Re: Phase II Remedial Investigation Work Plan, Revision 1
OU3: Former Plant Site Area, Upland Portion of the Southeast Area, and Bluff Area
DePue Site, DePue, Illinois

**WORK PLAN
FOR
PHASE II REMEDIAL INVESTIGATION
OU3: ON-SITE SOILS AND GROUNDWATER
REVISION 1**

**DePue Site
DePue, Illinois**

PRELIMINARY AREAS OF DETECTED
GROUNDWATER IMPACT
UWBZ, AQUITARD, AND BLUFF
DEPUJE SITE

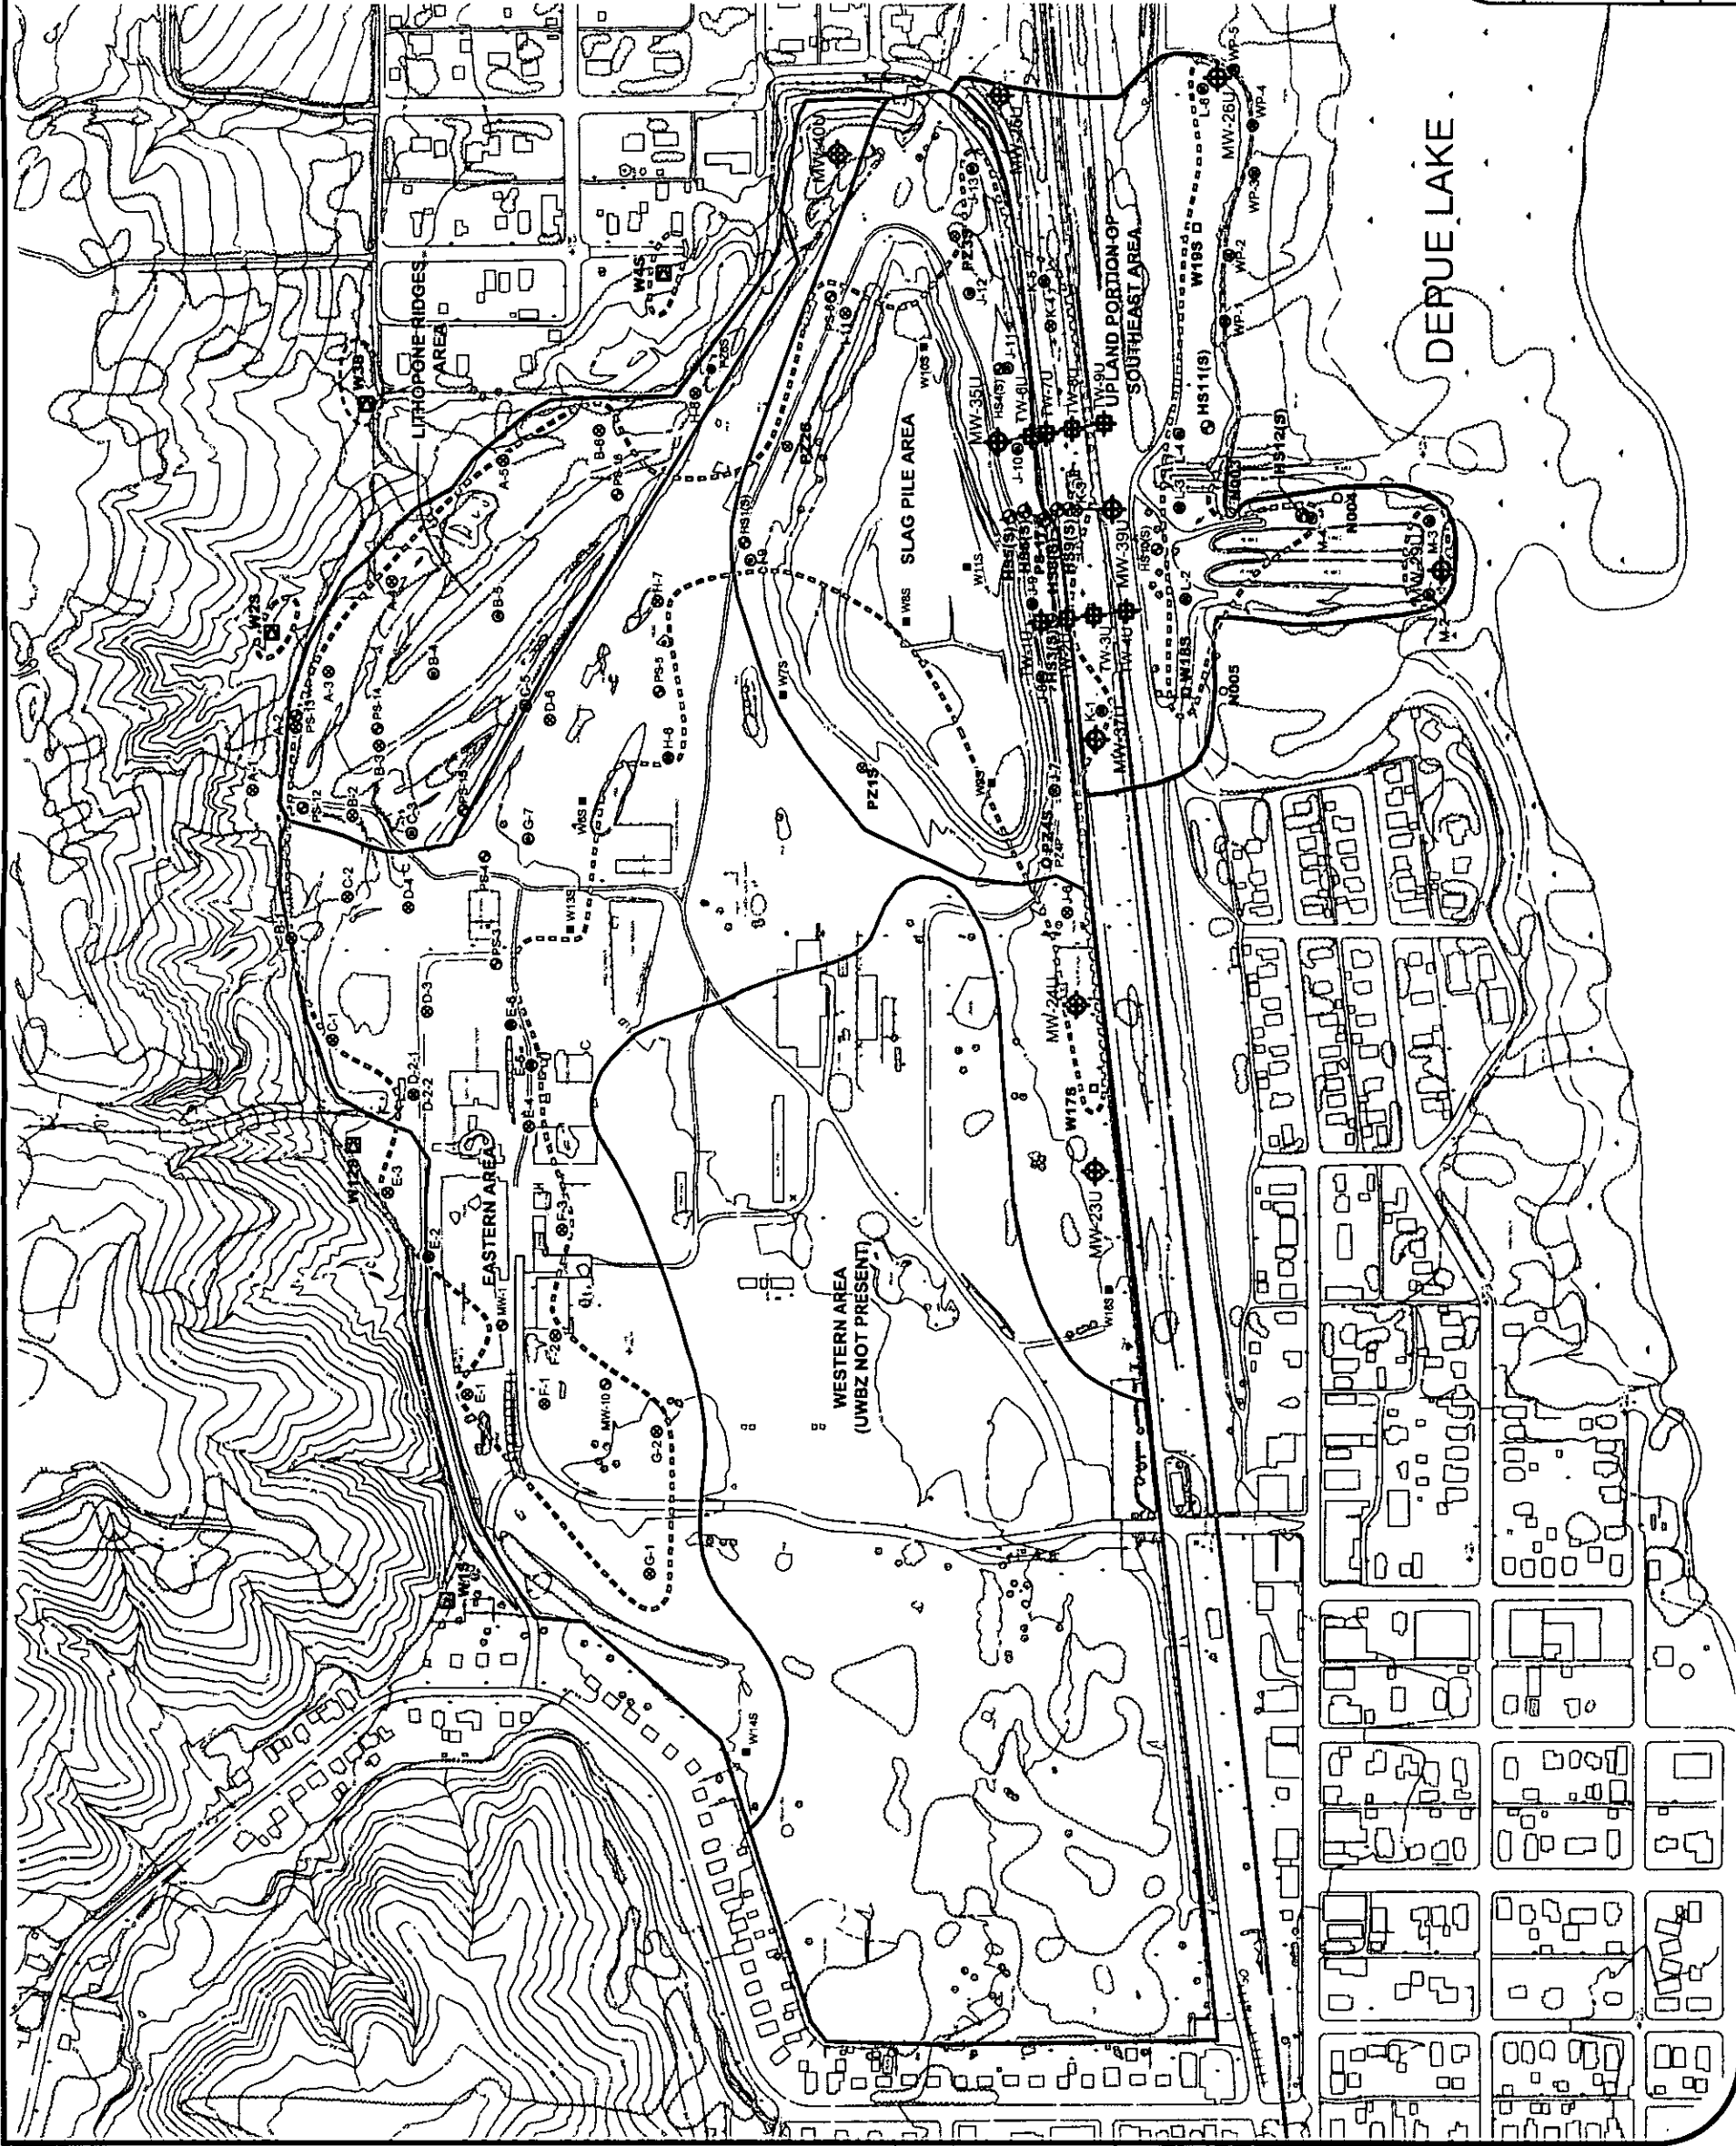
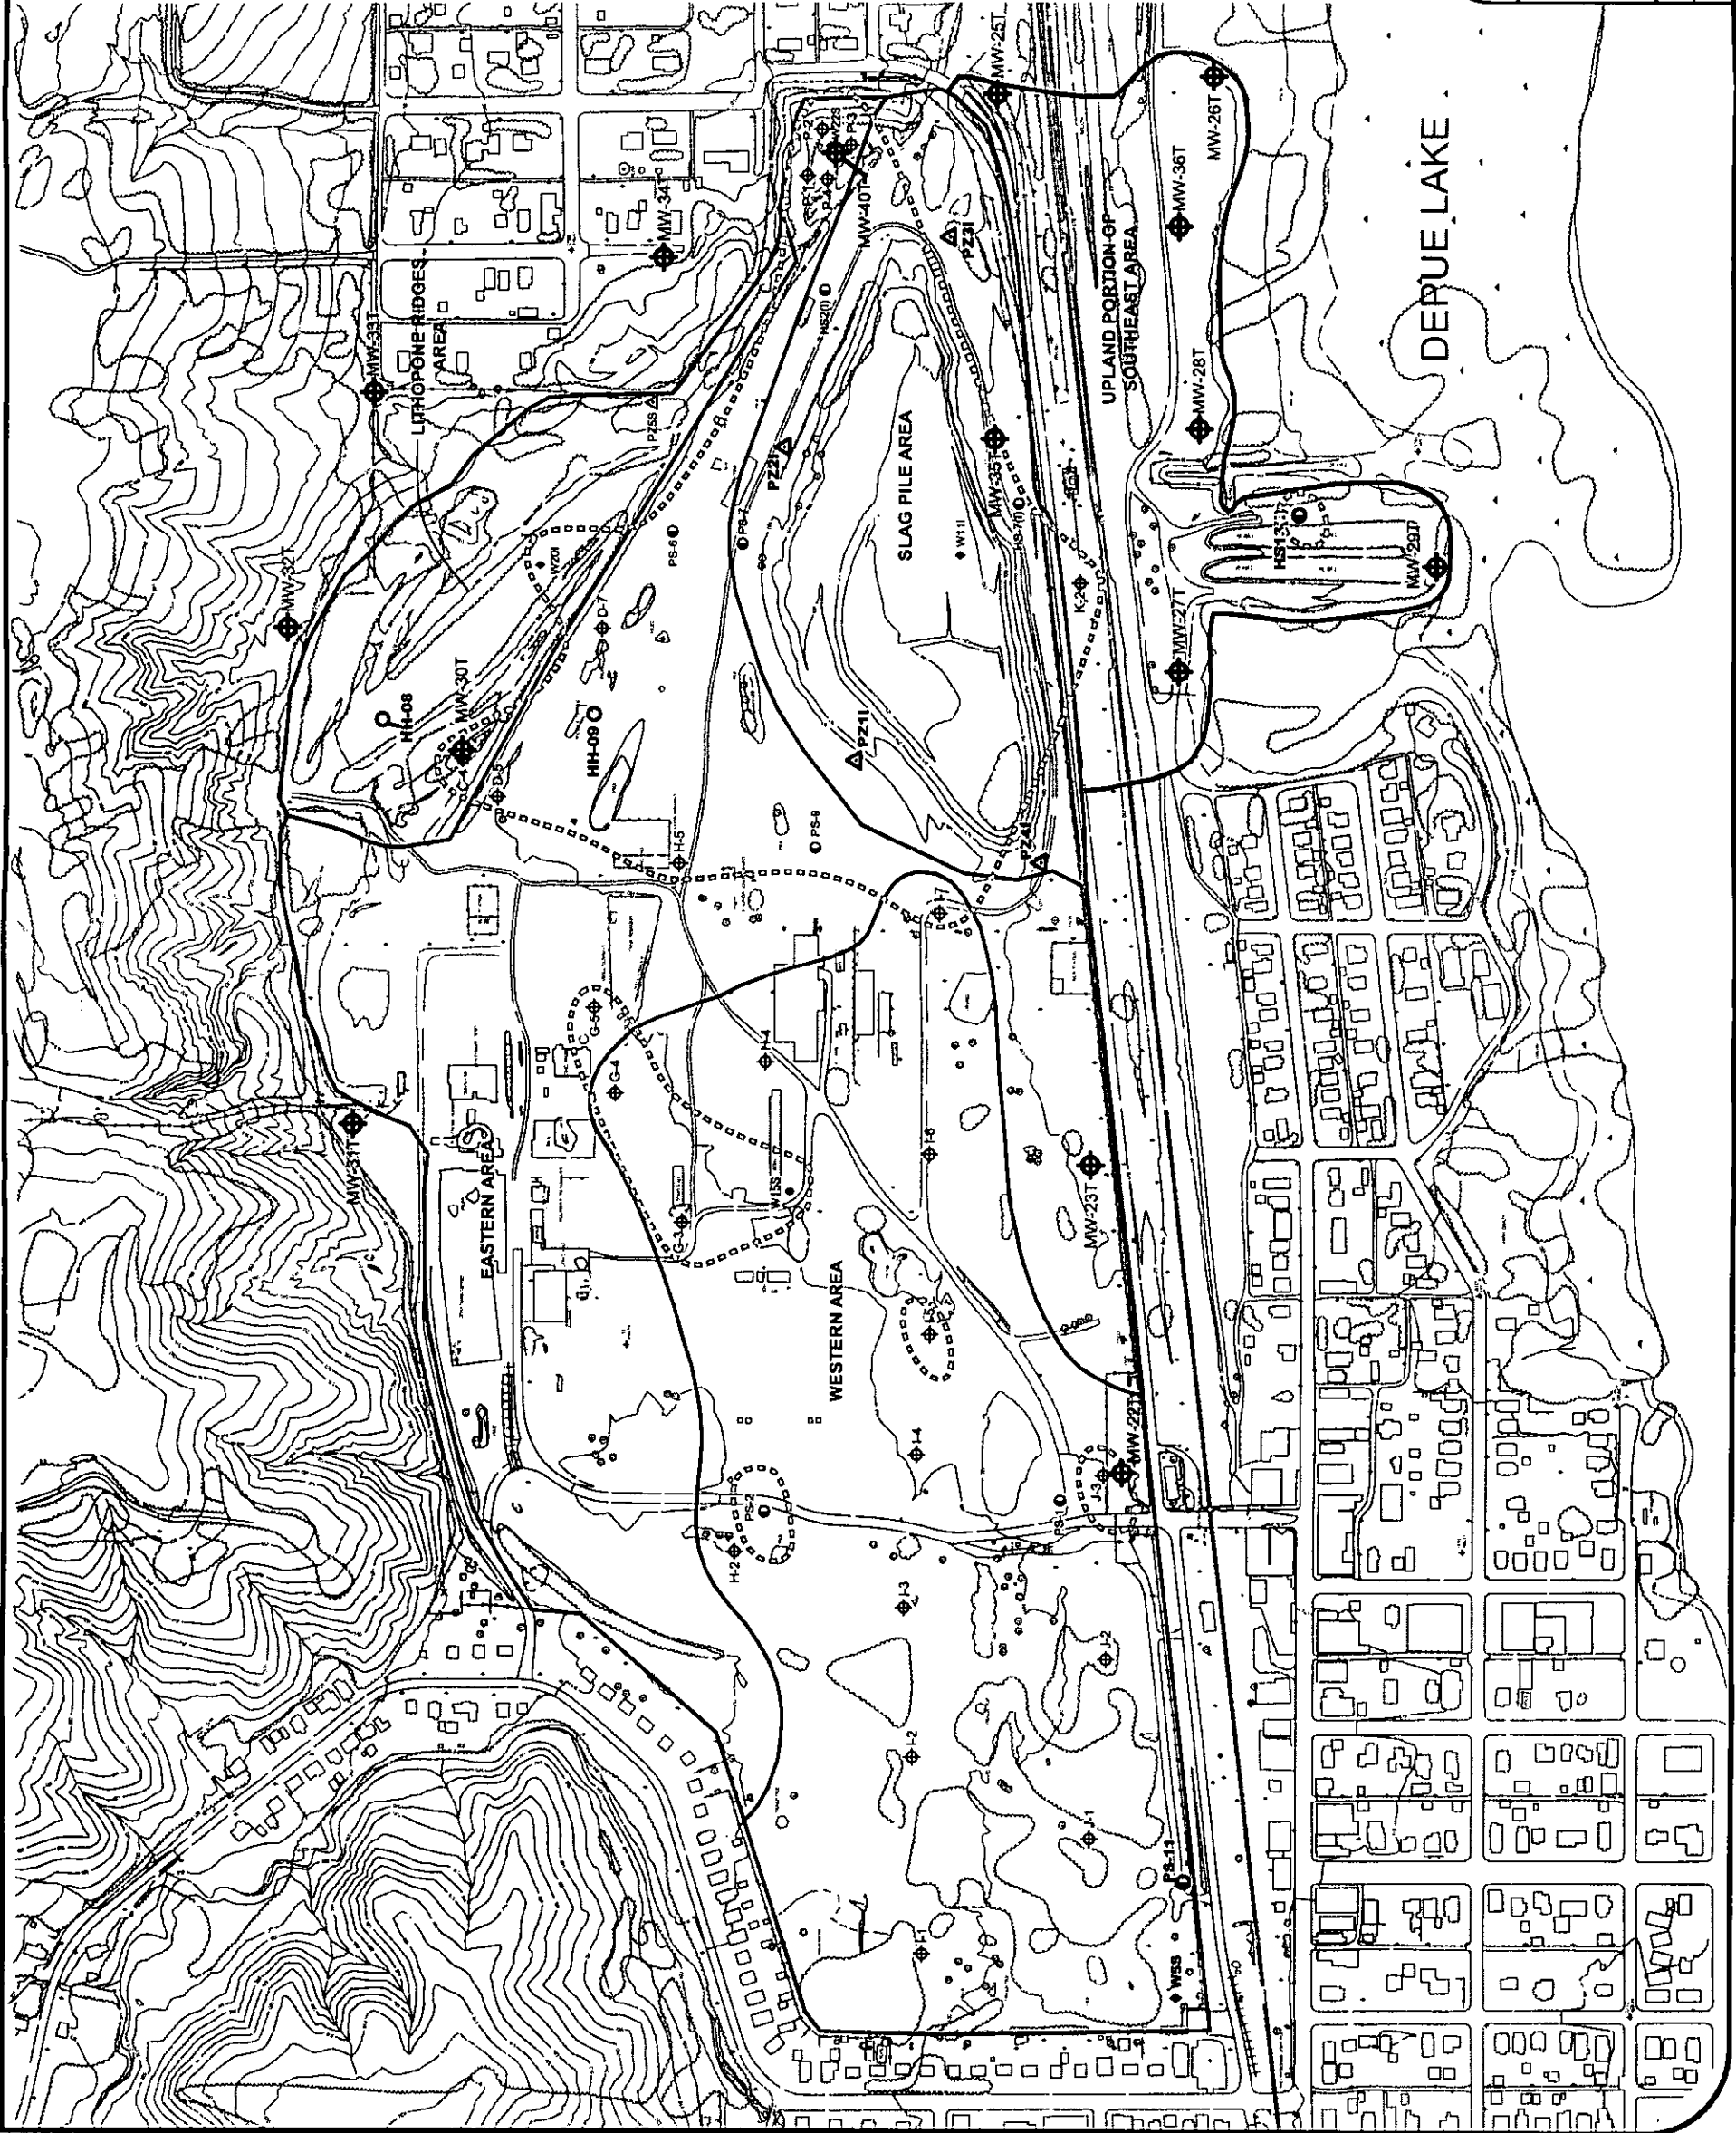
- c) *Figures 4-1 and 4-2 do not include groundwater results from water samples collected from temporary wells in soil borings that were not completed as monitoring wells or piezometers. In many cases, water samples from these borings contained concentrations of contaminants above HCOPC screening values. In Figure 4-3 a radium228 exceedance in well W13D and manganese exceedances in W2D and W17D are ignored. Therefore the figures do not accurately reflect the extent of detected groundwater impacts.*

The DePue Group will revise Figures 4-1 and 4-2 to include groundwater results from the temporary wells. The Phase II RI Work Plan proposes permanent wells near the location of some historical temporary wells. Results from temporary wells may be superseded by results of nearby permanent wells during Phase II RI reporting.

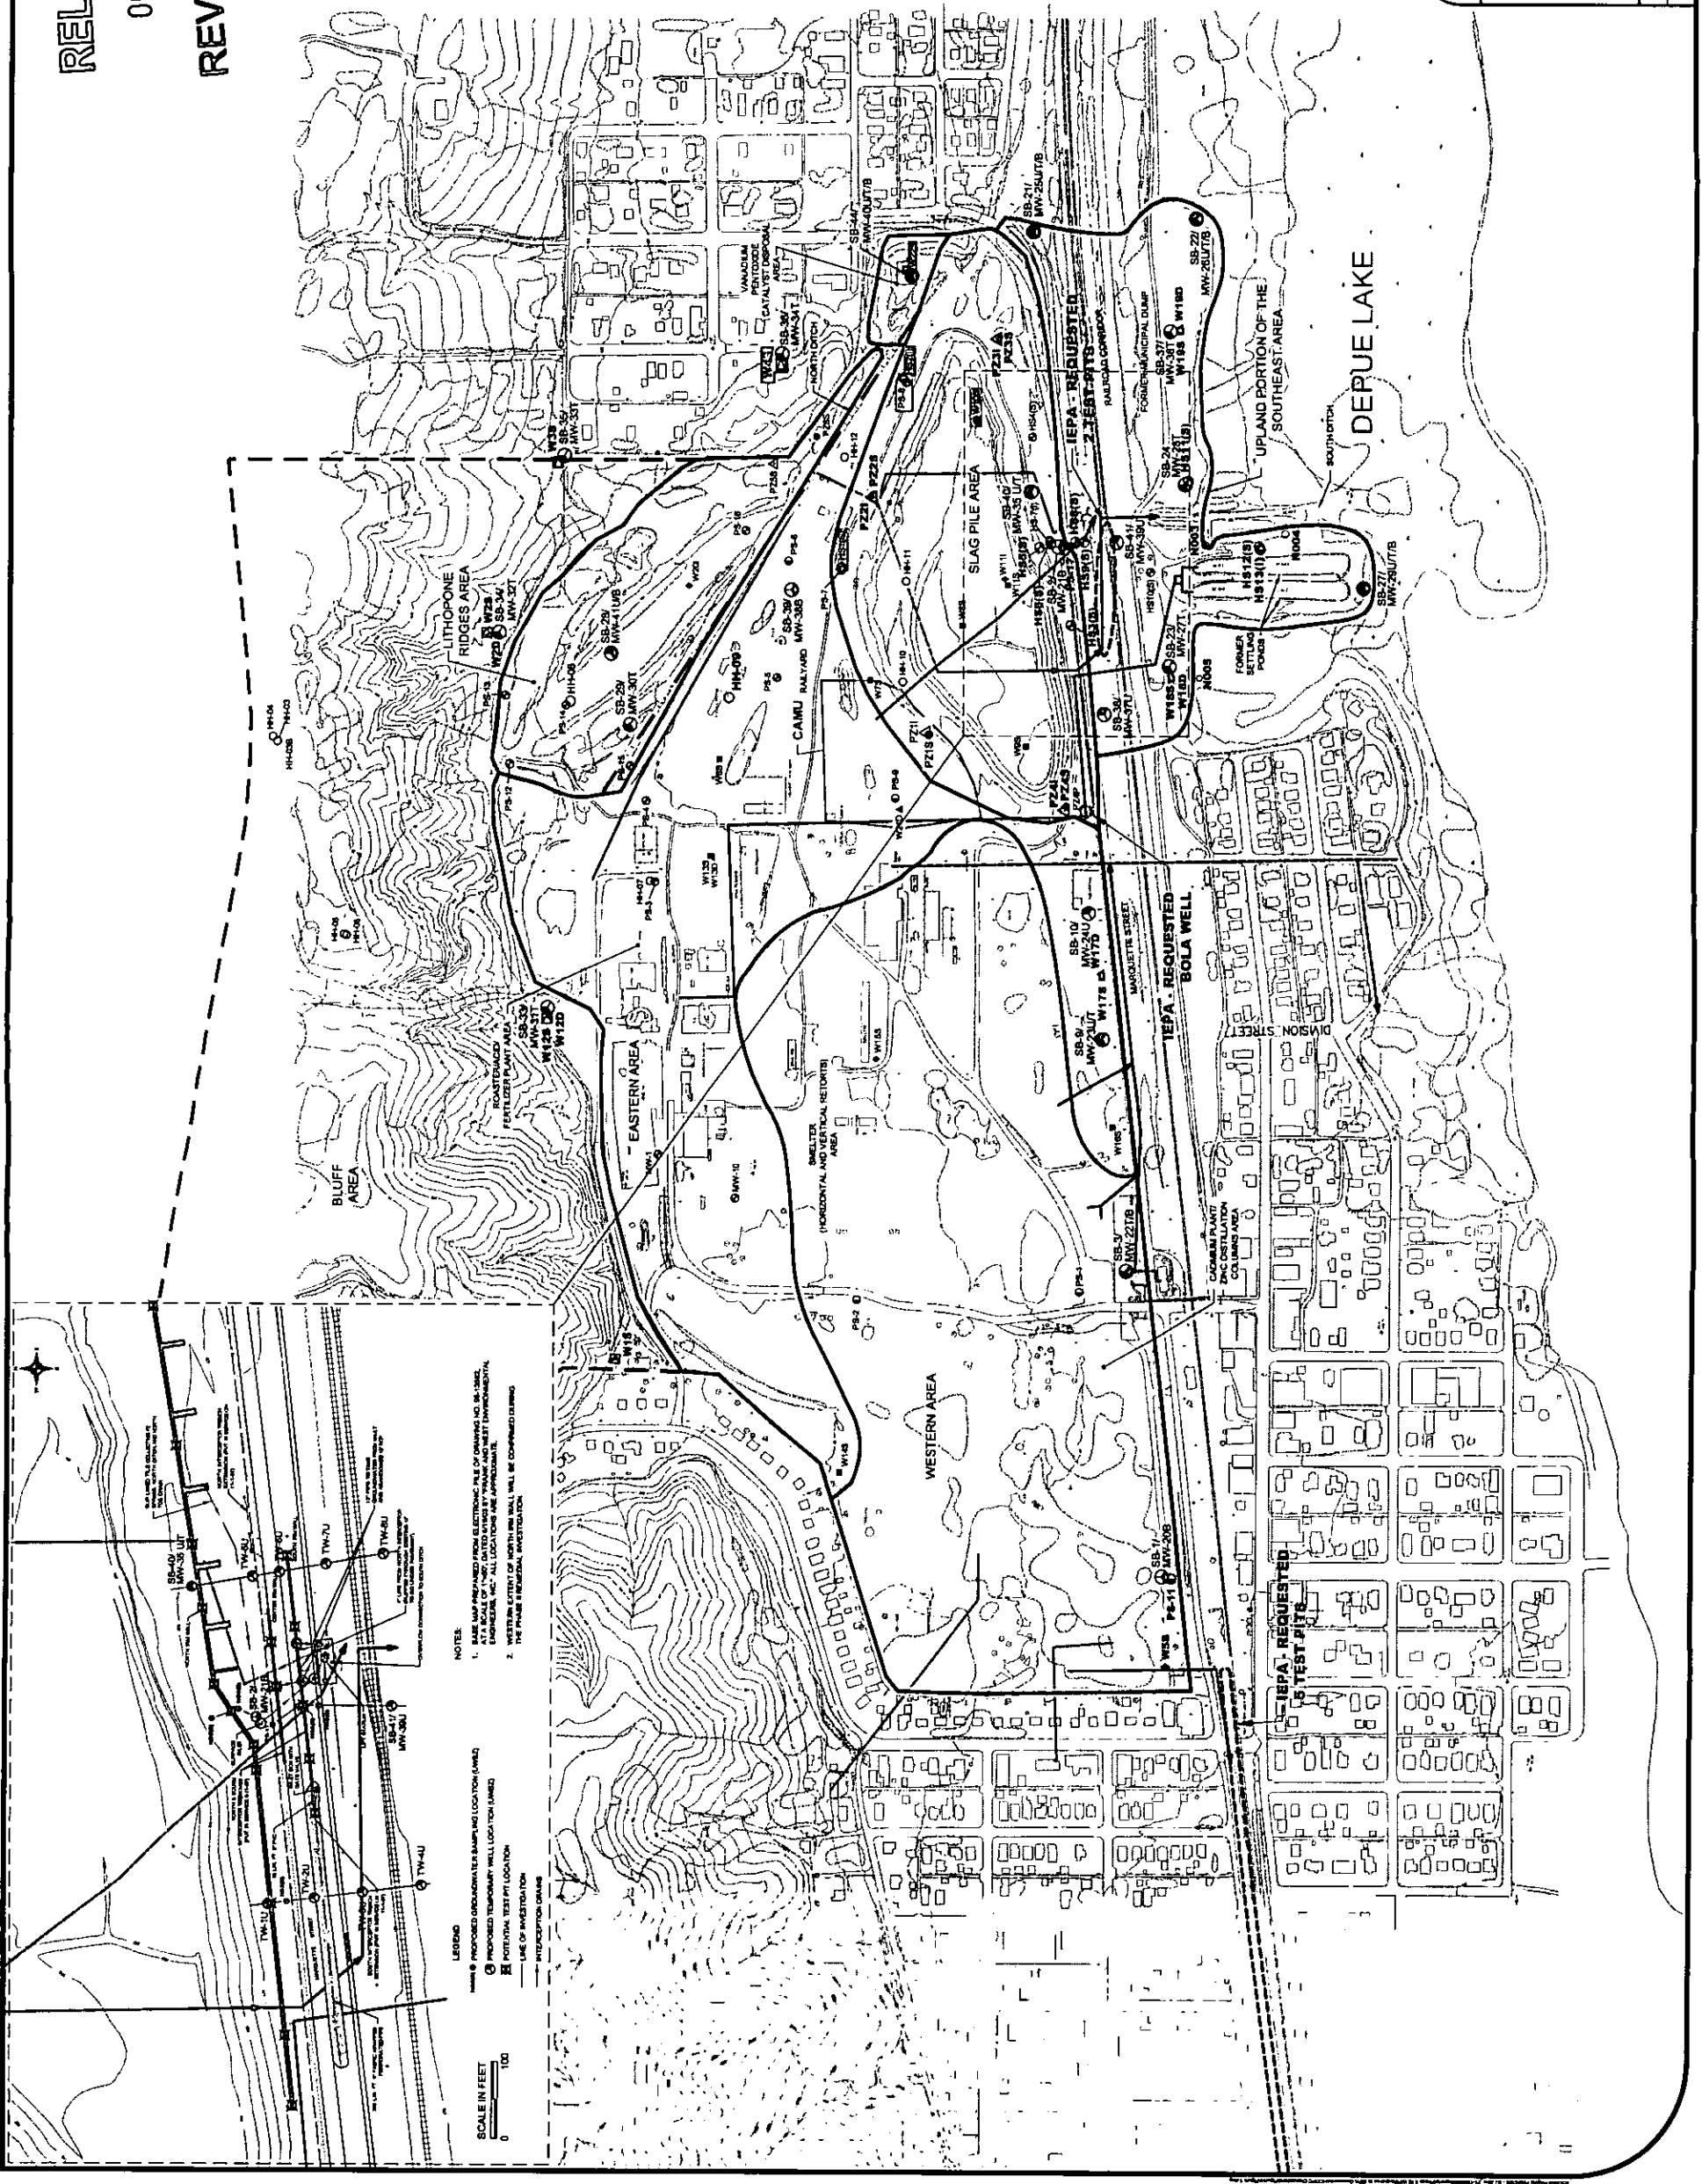
- b) *On the inset of Figure 5-2, the locations of wells relative to the positions of the IRM walls, interceptor trenches etc. do not match those shown on Figure 1-10B of the Phase I RI Report. We've been trying to get a correct Figure for this area since 2003.*

The locations of the wells, IRM walls, and interceptor trenches shown on Figure 5-2 are the correct locations based on current information. Configurations shown on earlier drawings
